**CONCEPTUAL MASTER
POTABLE WATER SYSTEM REPORT
FOR
SERENO CANYON**

City of Scottsdale
Water Resources Department
Basis of Design Review Comments

Project: Sereno Canyon

Conceptual Master Potable Water System Report comments:

PLATE 4

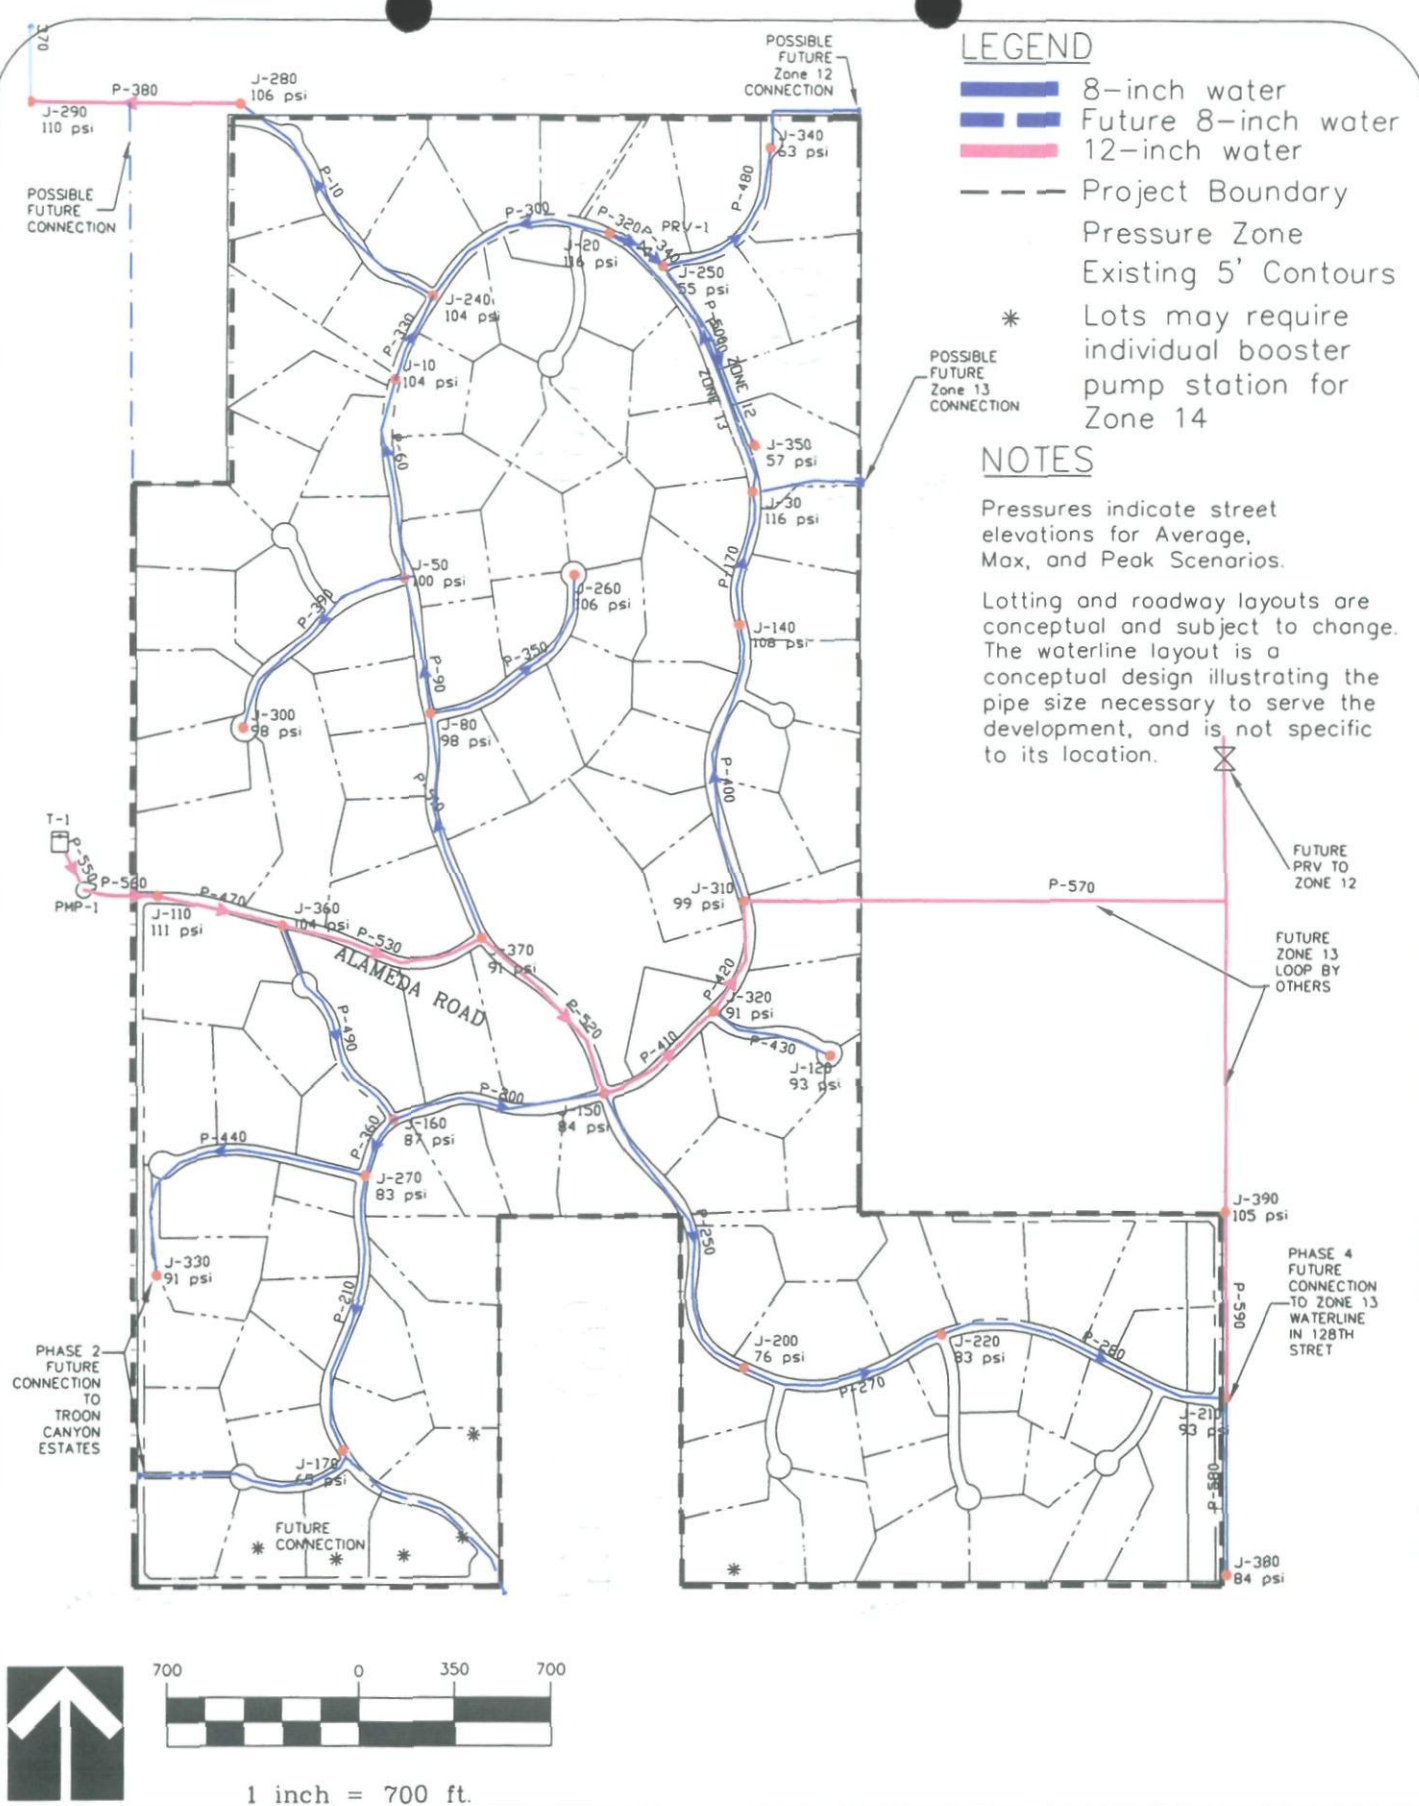
5. Plate 4, Option 1 is to include a line from the cul-de-sac off pipe 390 to the northwest property line for a future connection to the adjacent property. A stub to the property line shall be included off node J-310. A water line will be installed along the 128th Street frontage to this project.
